**REZONING,
PLANNED UNIT DEVELOPMENT
& SUBDIVISION STAFF REPORT**

Graf Dairy Subdivision

2955 Dauphin Street

APPLICATION NUMBER 38,39,40,41 DATE September 20, 2007

SITE PLAN

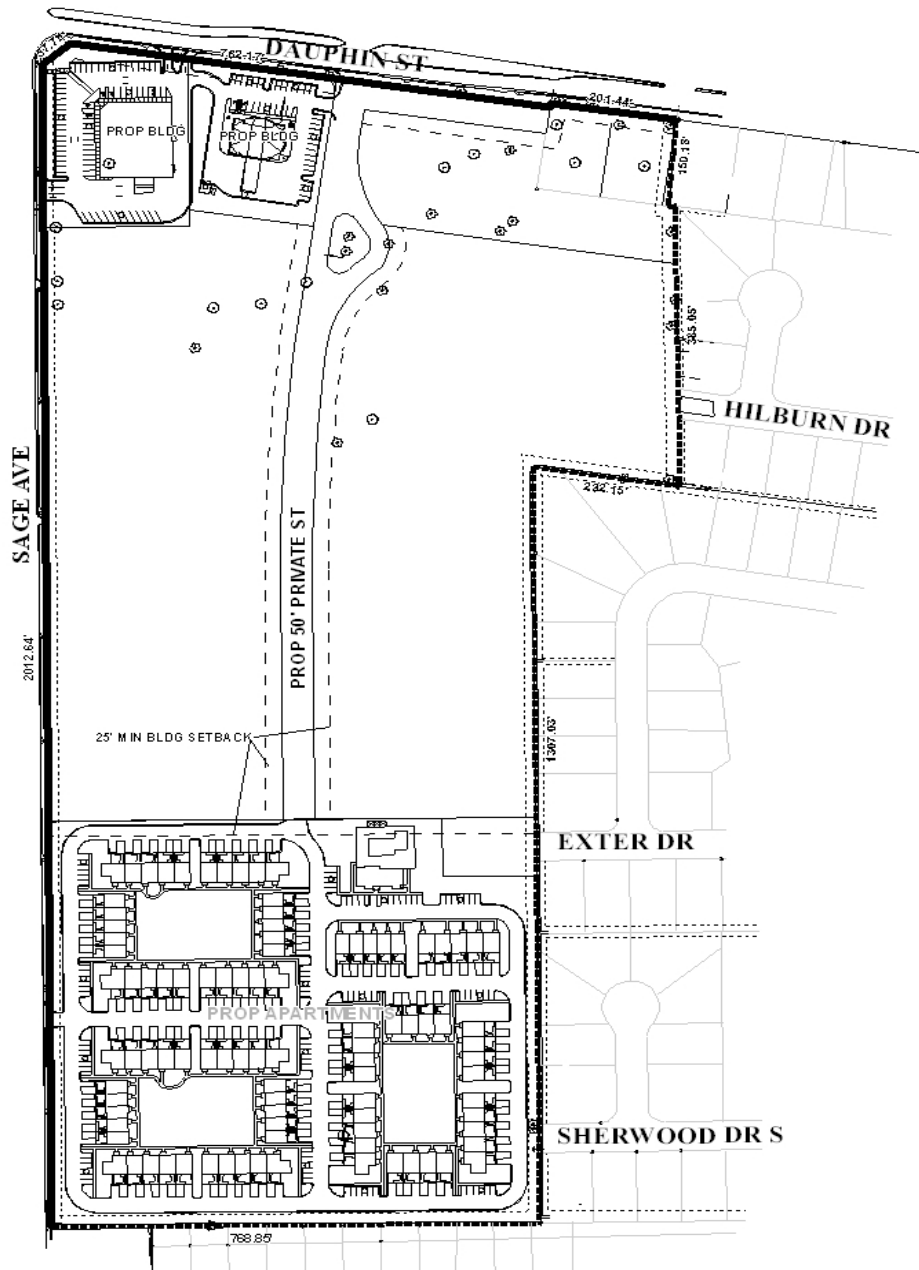
One of the primary concerns is that of the private street and compliance with Fire Department comments/requirements – especially as relate to the design of the private street, its length, and its termination. Further, neither the application nor the plans indicate if the condominium development is to be gated at the private street, nor is there any indication of how the access to Sage Avenue is to be regulated for emergency only. Another issue relating to design of the private street is the area of private street right-of-way that runs adjacent to Dauphin Street, in front of Lot 1. There is no explanation or illustration of the purpose of this section of private street.

There is no indication on the site plan (with the exception of Lot 2) as to the proposed location of any dumpster or other waste storage facility. If the applicant utilizes a dumpster, the location of the storage area for the dumpster must be indicated on the site plan, and the location and required screening must comply Section 64-4.D.9. of the Zoning Ordinance, as well as with all other applicable regulations. Additionally, there is no indication on the site plan as to the proposed location of any mail kiosk. This is one point that the applicant may want to pursue with the USPS, because traversing the private street to access the condominiums may be an issue.

A sidewalk along Dauphin Street will be required as part of the development, if approved, as will any necessary repairs to the sidewalk along Sage Avenue (or construction of new if dedication and/or roadway improvements are required). The site plan should be revised to show both sidewalks.

regarding compliance of Lot 6 with the requirement that 60% of the required landscaping be located between the buildings and the street. Also, the site plan does not show specific compliance with the tree requirements of the Ordinance, which will be required as the individual lots are developed.

The plan indicates the provision of a 20' buffer along the east and south property line, where the site is adjacent to residential development. During a community meeting the applicant offered to maintain this buffer in a natural vegetative state. While the depth of this buffer exceeds that required by the Zoning Ordinance, there is some concern as to the consistent density of this buffer, especially if a majority of the natural vegetation is deciduous. Therefore, in addition to the vegetative buffer, the provision of a 6' (minimum) privacy fence should be required where the site abuts residential properties.
